From: Hanson, David L - DNR
Sent: Wednesday, March 2, 2022 4:25 PM
To: E.J Herr
Cc: Jessica Guzman; Susan A. Winnen; Donna Volk; Matthew J. Sullivan; Stephen Meer, P.E.; Adam Roder (aroder@thesigmagroup.com); Moll, John G - DNR (Gregory); Hanson, David L - DNR
Subject: RE: [EXT] 0241531534: Continuing Obligations Modification Request (NR 727)
Attachments: 20210915_193_CO_Mod_NTP.pdf

Subject: Post-Closure Modification Notice to Proceed/Approval to Manage Contaminated Soil and Solid Waste Under Wis. Admin. Code § NR 718.12 and § NR 718.15 on Site at the Former DuPont/Allis Chalmers Property, 4001 E. Lake Vista Pkwy., Oak Creek, WI DNR BRRTS Activity #s: 02-41-278988 & 06-41-554563 (and others), FID #341041580; and the Former EPEC Polymers Inc./The Boerke Site, 4200 E. Lake Vista Blvd., Oak Creek, WI DNR BRRTS Activity #s: 02-41-531534 & 06-41-554566, FID #241869870

LAKESHORE COMMONS PHASE 1
OAK CREEK, WI

OVERALL PHASE 1 EROSION CONTROL PLAN

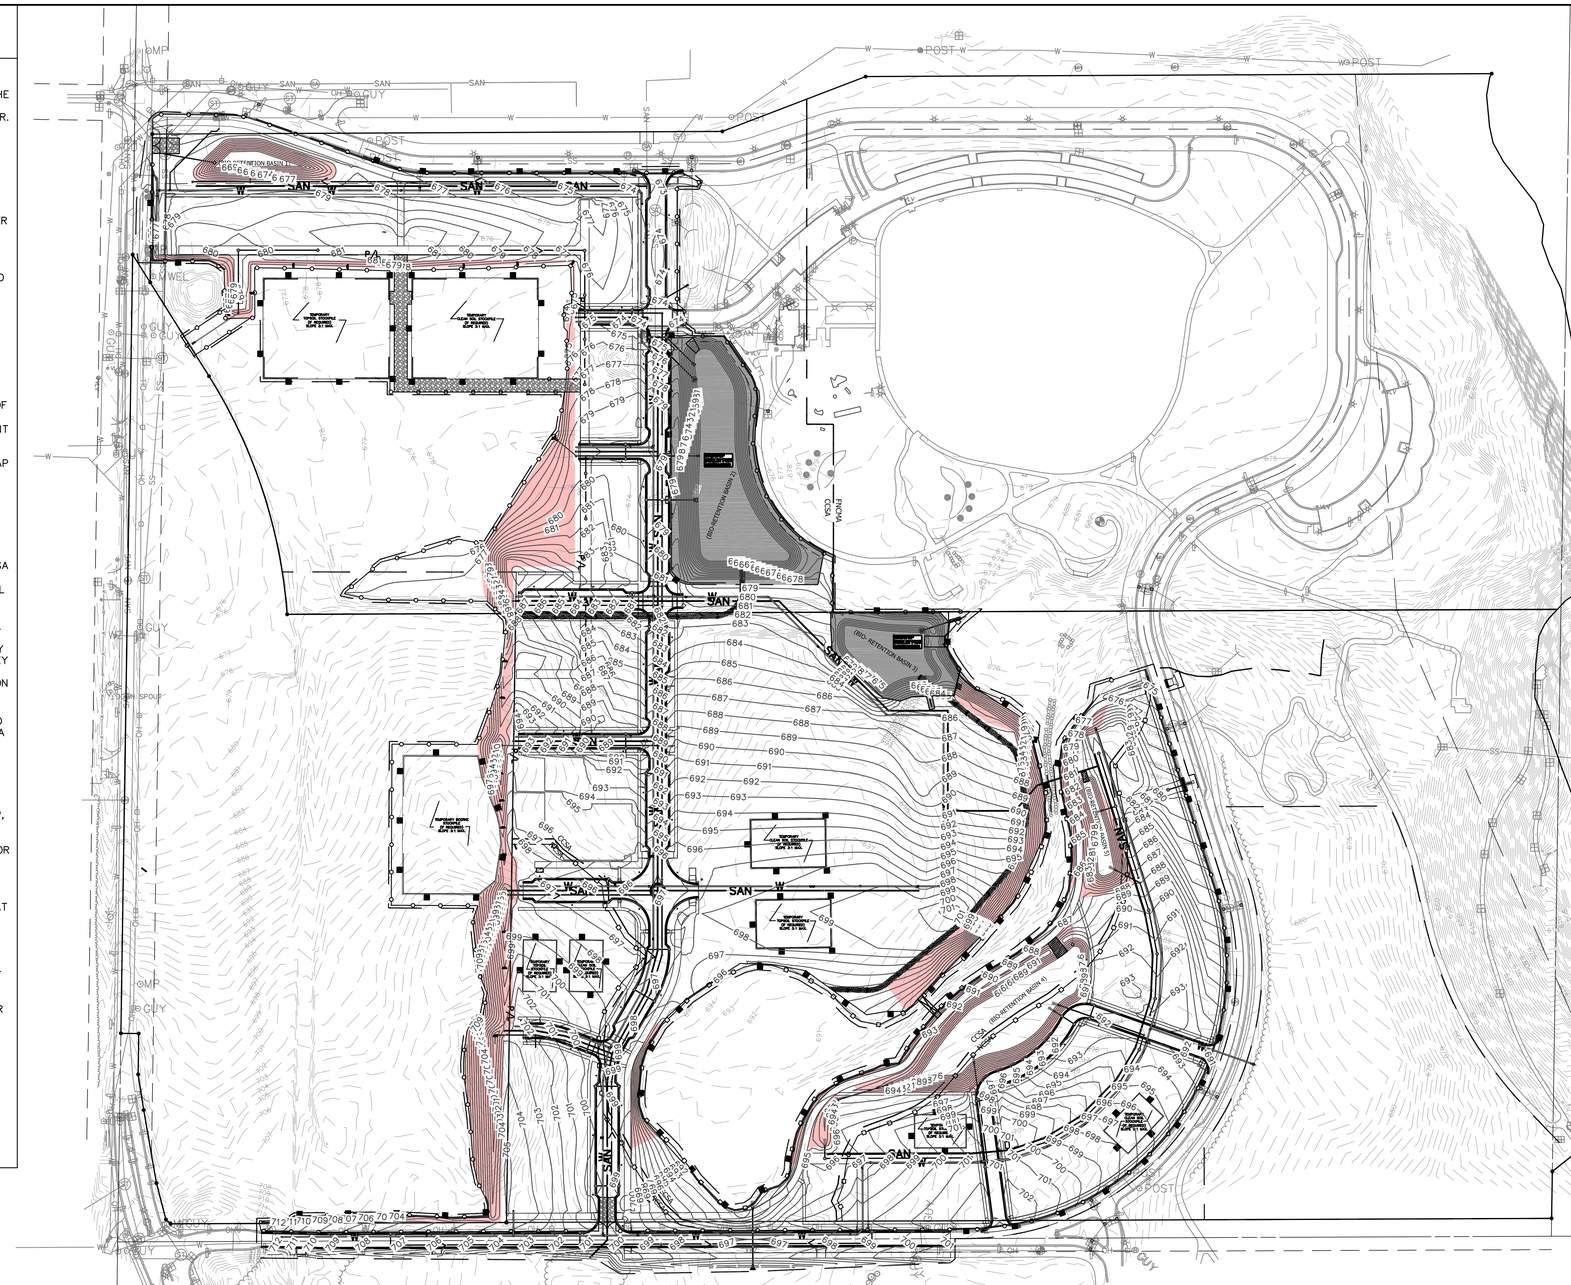
After mass grading and construction of bioretention basins, roadways and utility mains are complete and the temporary minimum 2-foot soil cap is in place, fencing around the Phase 1 area will be removed (fence locations are depicted on the attached Overall Phase 1 Erosion Control Plan Figure). If construction at any of the home sites is anticipated to encounter contaminated soil, a temporary fence will be installed around that home site (or group of sites, if appropriate) to restrict access by adjacent home occupants and therefore limit potential direct contact with contaminated soil.

PHASE 1 CUT AND FILL

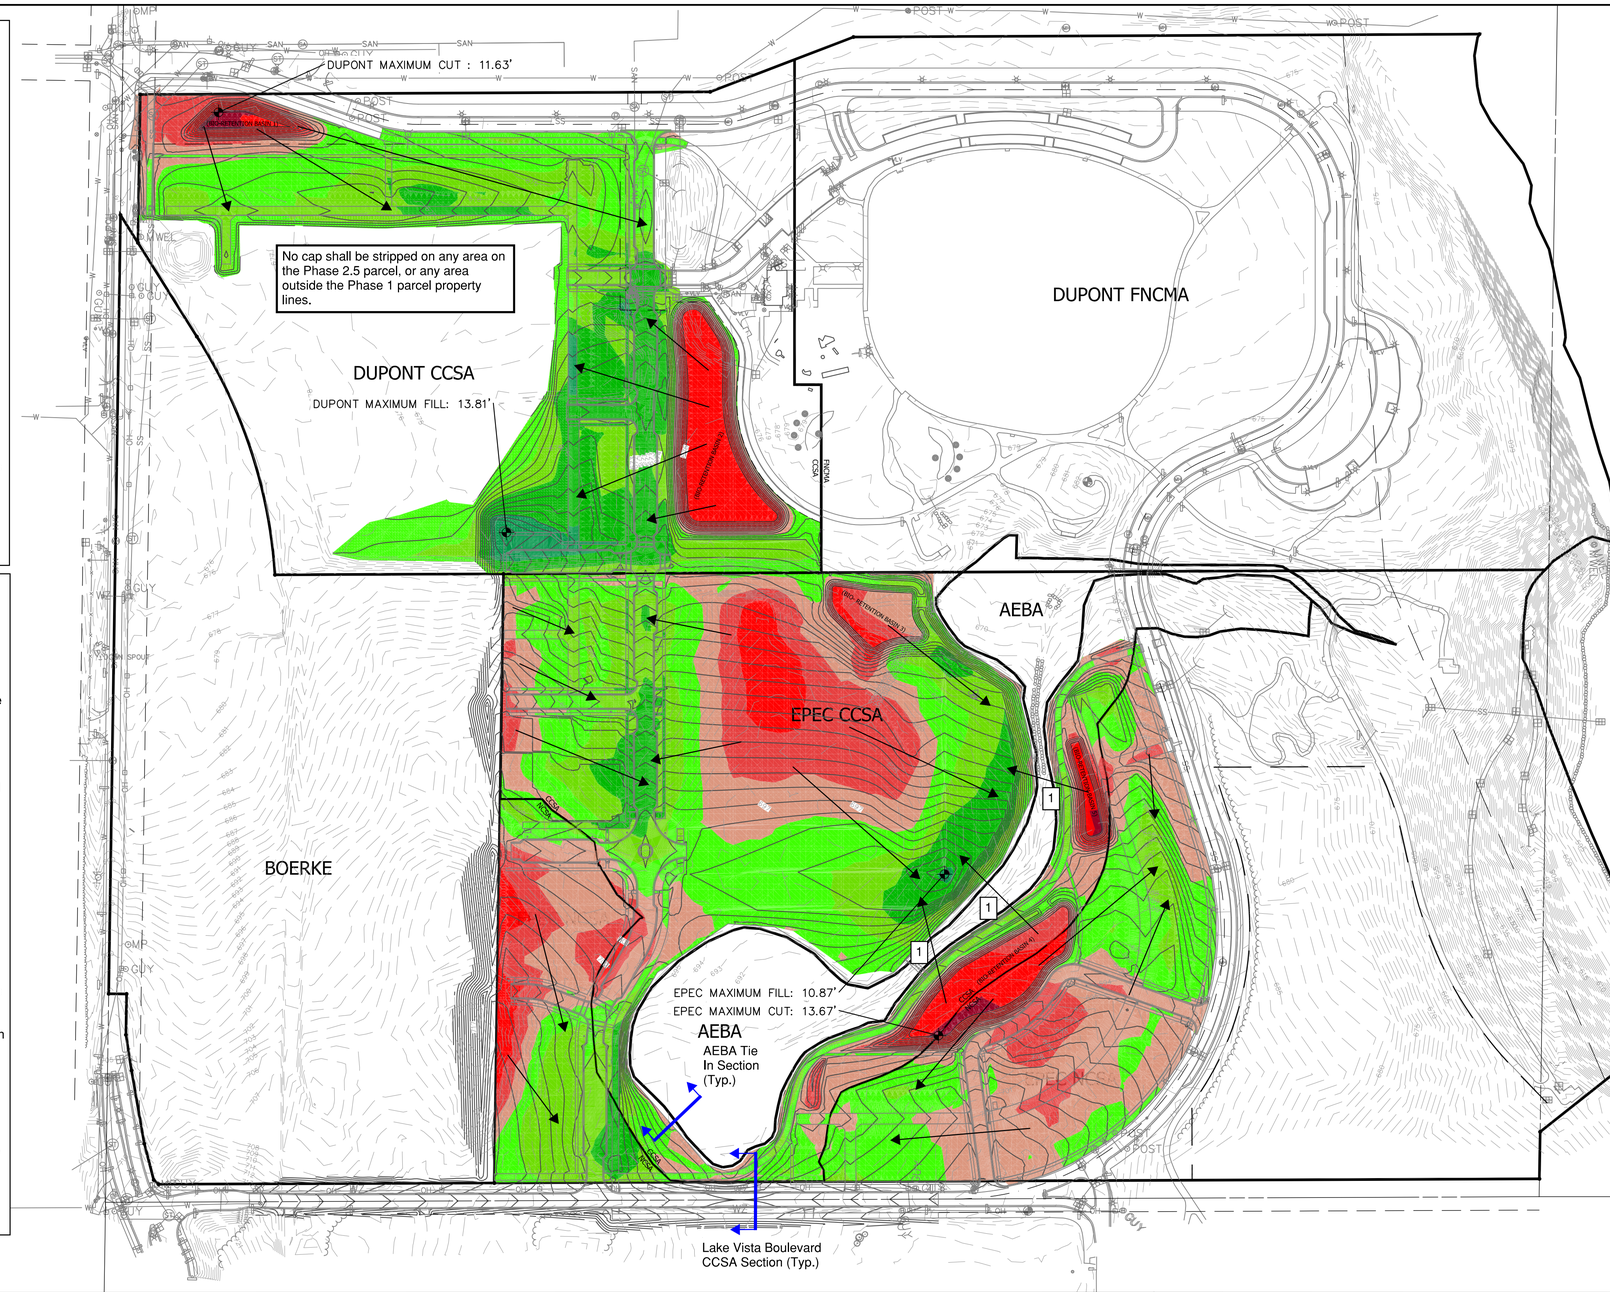
Managing contaminated soil in areas of the properties identified on the Phase 1 Cut and Fill Figure of the Request will meet the locational criteria listed under Wis. Admin. Code § NR 718.12 (1) (c).
